Item 3.**Development Application: 43 Avona Avenue, Glebe - D/2020/1453**

File No.: D/2020/1453

Summary Recommendation: The development application is recommended for approval, subject to conditions.

Figure 28: Proposed material schedule for the Avona Avenue elevation. Note; GL1 (glazing) and SCN-101 (perforated screen) are location on the north (side) and west (rear) elevations. Glass balustrades to be replaced are highlighted by red dashed lines.

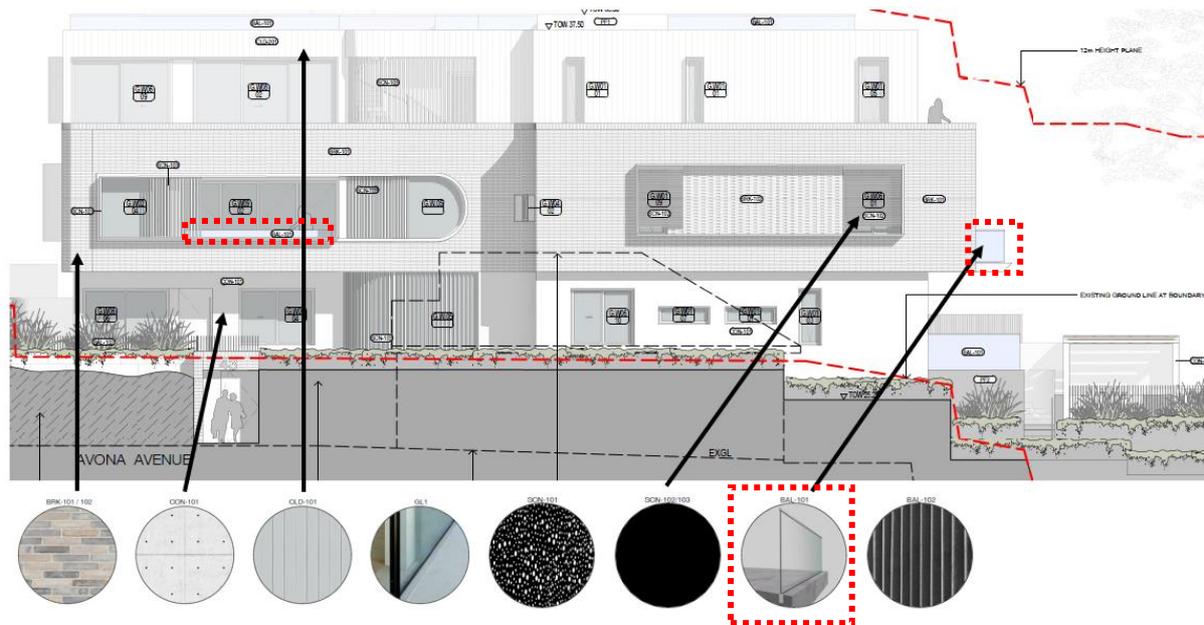
49. The external finishes are considered to be generally acceptable, subject to the submission of more specific details of materials and colours. It is noted that glass balustrades are proposed for the balconies to Avona Avenue and the eastern elevation, which is not characteristic of the heritage conservation area. It is recommended that the glass balustrades be replaced with a contemporary metal balustrade with vertical balusters.
50. With the recommended design modification conditions relating to the replacement balustrades, the proposed materials and colour scheme will result in a contemporary building that transitions between unit development to the north and lower level single 'contributory' buildings to the south.

Figure 32: Proposed north elevation. Window GW05-01 is highlighted by red dashed lines.

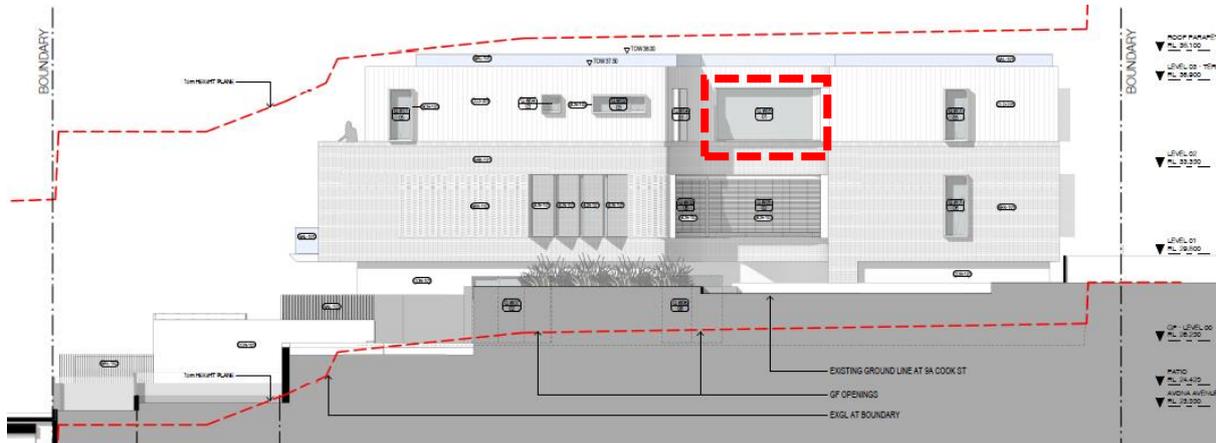
61. The main dwelling includes new windows at all elevations at levels 1 and 2. Bedroom and bathroom windows are to be located at levels 1 and 2 to the west elevation (facing 14 Avona Avenue) and are set back 250mm from the boundary. Windows to the music room and dining areas at level 1 and the childrens' retreat and parents retreat at level 2 at the north elevation are to be set back 150mm.

62. The majority of windows are to be fitted with angled screening to avoid direct sightlines to and from the site. Those windows that are not screened are generally highlight windows set 1.8 metres above the finished floor level. It is noted however, that the large window to the corridor of level 2 at the northern elevation is not fitted with any screening or obscure glazing. Although not a highly trafficable space, this window will be in close proximity to balconies of 9A Cook Street, creating privacy impacts. It is therefore recommended that this window (labelled G W05-01 in elevation) either becomes a highlight window or be fitted with louvres or an obscure glazed treatment.

Figure 34: Proposed northern elevation of subject site. Balcony projection at level 1 to be removed is highlighted by dashed lines.

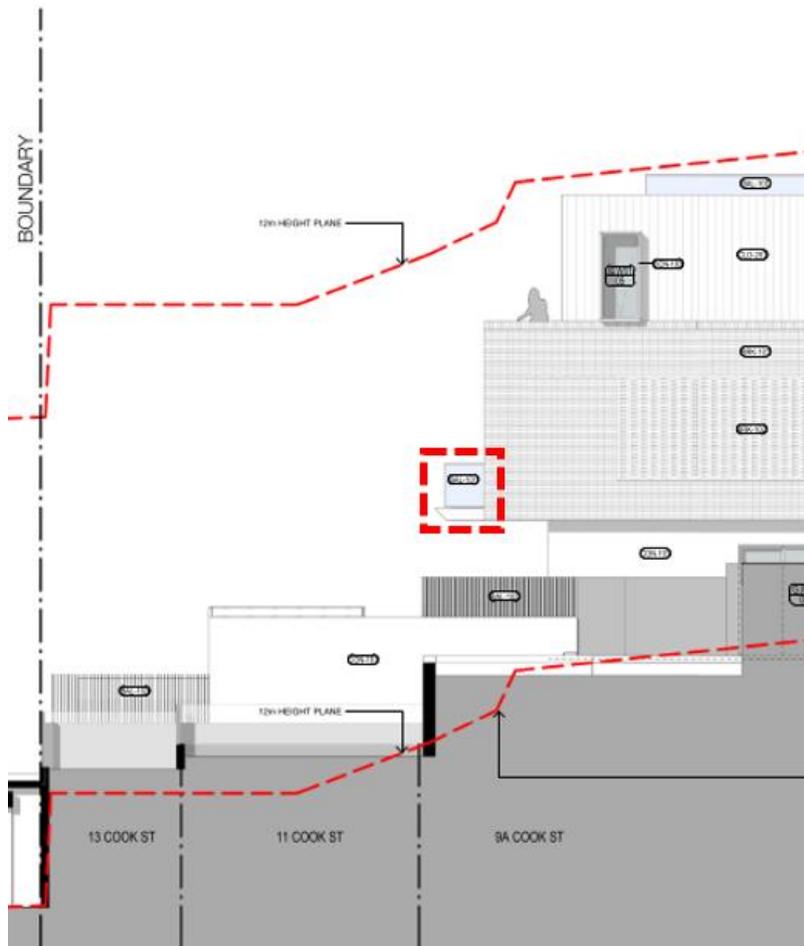
66. The balcony at level 1 will result in overlooking of dwellings to both side boundaries which can be avoided with design modifications. It is recommended that the balcony be amended so that it does not project any further than the side blade walls (i.e. removing approximately 1.4m width). See north elevation below with projected balcony to be removed.

Figure 35: Proposed level 2 plan. Level 2 balcony to be modified is outlined by red dashed lines.

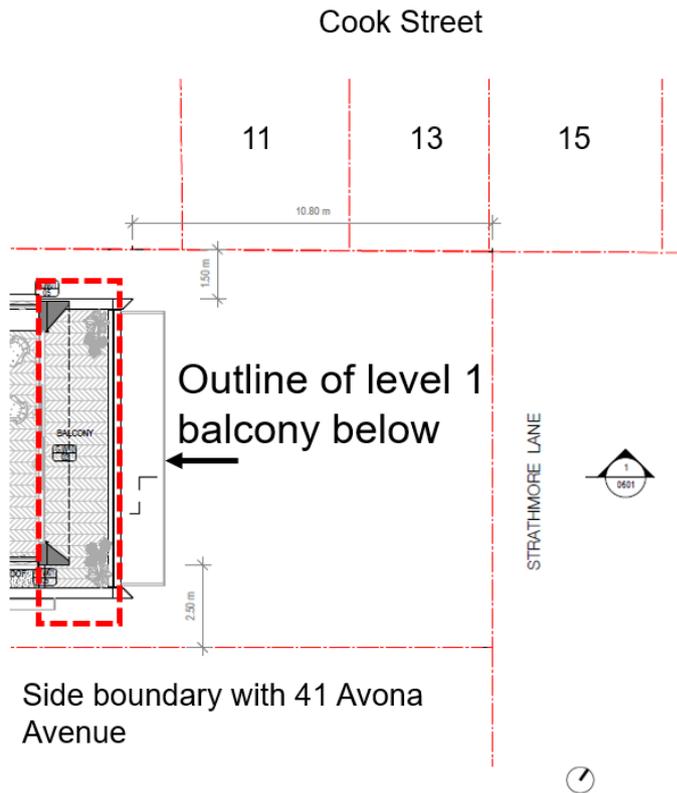
67. At level 2, the balcony extends the full width of the building envelope, creating adverse privacy impacts to both 41 Avona Avenue and Nos. 11-19 Cook Street due to its large area and its location above surrounding properties. Privacy measures, such as screening or blade walls are unlikely to mitigate impacts to neighbouring dwellings. Such measures rather, will add to view loss impacts, and increase bulk and scale at level 2 which is not supported. It is therefore recommended that whilst floor to ceiling glazing may remain in place at this elevation, a balustrade can be installed that sits flush to the glass line, and the remaining balcony area be blocked off with roofing so it cannot be used.

68. Conditions incorporating the above amendments are provided in Attachment A.

Figure 36: Proposed roof plan depicting terrace area

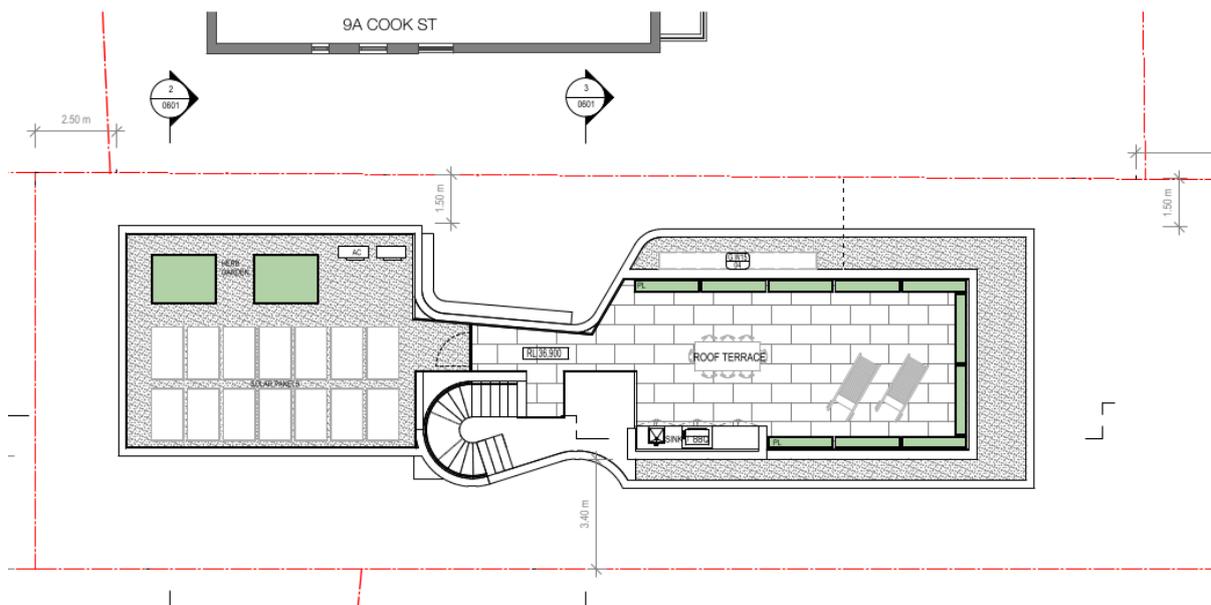
70. The large roof terrace is considered inappropriate in the context of apartment buildings and terraces in such a dense urban environment. The terrace allows for the congregation of large groups of people, creating adverse visual and acoustic privacy impacts to surrounding development, contrary to Section 4.1.8(b) of the Sydney DCP 2012. It is recommended that the roof terrace be deleted, noting that ample private open space is provided at ground level in excess of DCP requirements.

71. The deletion of the terrace area means a large staircase to the roof is no longer required, removing some bulk from the second floor of the development. Given that there are solar panels, air conditioning units and a herb garden also proposed at rooftop, it is recommended that an amended level 2 and roof plan be submitted showing the relocation of the solar panels, air conditioning units and herb garden.

Response: Agreed. The roof terrace is not supported and conditions are recommended for it to be deleted.

Figure 51: Site plan of existing trees

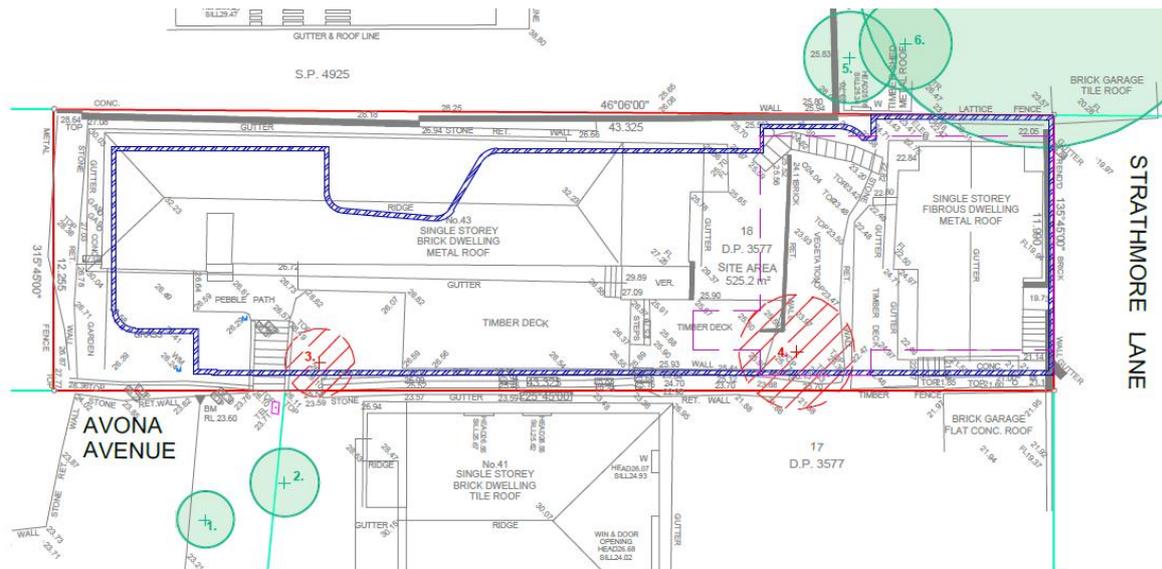
93. City staff have undertaken a site inspection to view the specifications and health of the Cheese tree. The tree is located on a small sandstone shelf on the eastern side of the property. The tree has previously been lopped and has limited root soil volume. As such, the tree has a moderate retention value. The City's Tree Management Unit does not object to its removal, subject to replacement trees being planted.

94. It is therefore recommended that 3 trees in total be planted within the site:
 - (a) 2 x trees that will reach a minimum height of 5 metres, canopy spread of 5 metres; and

- (b) 1 x tree that will reach a mature size of 8 metres and a canopy spread of 8 metres.
95. The proposed plans provide deep soil areas in some parts that are only to a depth of 300mm over sandstone, due to the site being regraded and cut along the western boundary. It is recommended that plans be provided depicting deep soil areas with a minimum depth of 1000mm over sandstone to allow for the planting of these trees.
